SERVICE INFORMATION BULLETIN

APPLICABILITY: 2001-2016MY Impreza (4Dr and 5Dr)
 2017-2018MY Impreza (5 Dr Only)
 2013-2018 Crosstrek
 2003-2018MY Forester
 2015-2018MY WRX and WRX STI
 2013-2018MY BRZ

NUMBER: 12-231-18

SUBJECT: Air Vent Grille Design Change

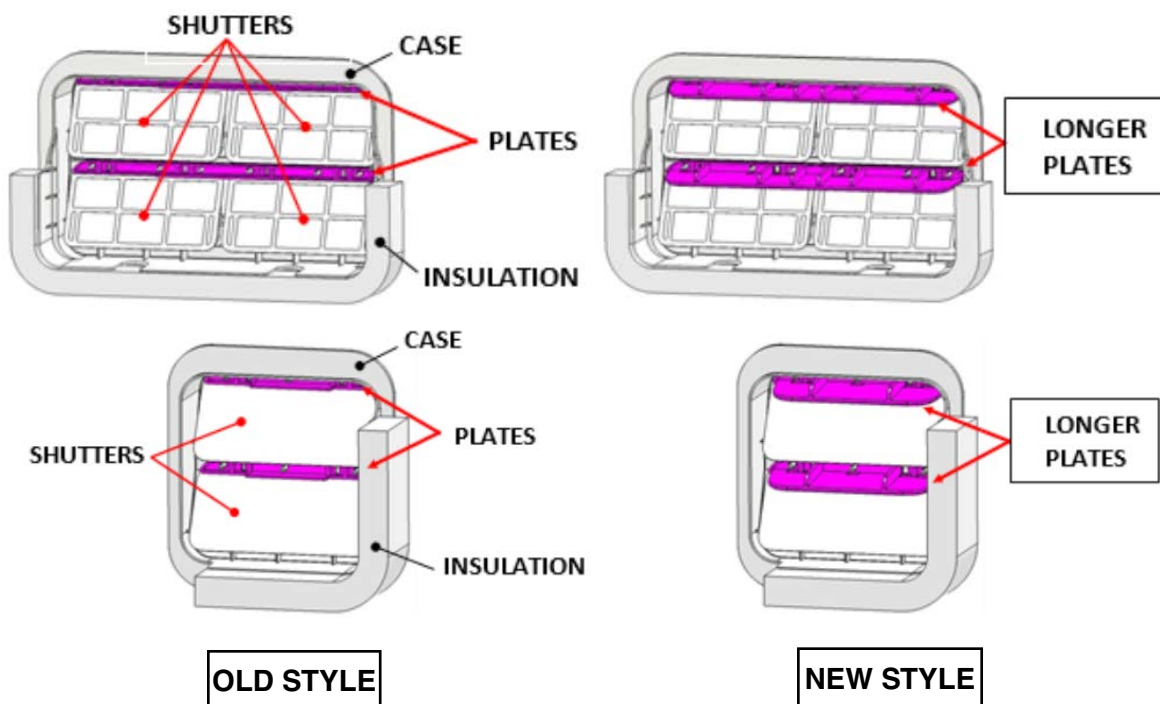
The new vent grilles have been redesigned with longer plate portions to prevent the shutters from becoming stuck open. Comparison images detailing both the Old and New-Style replacement parts are provided below.
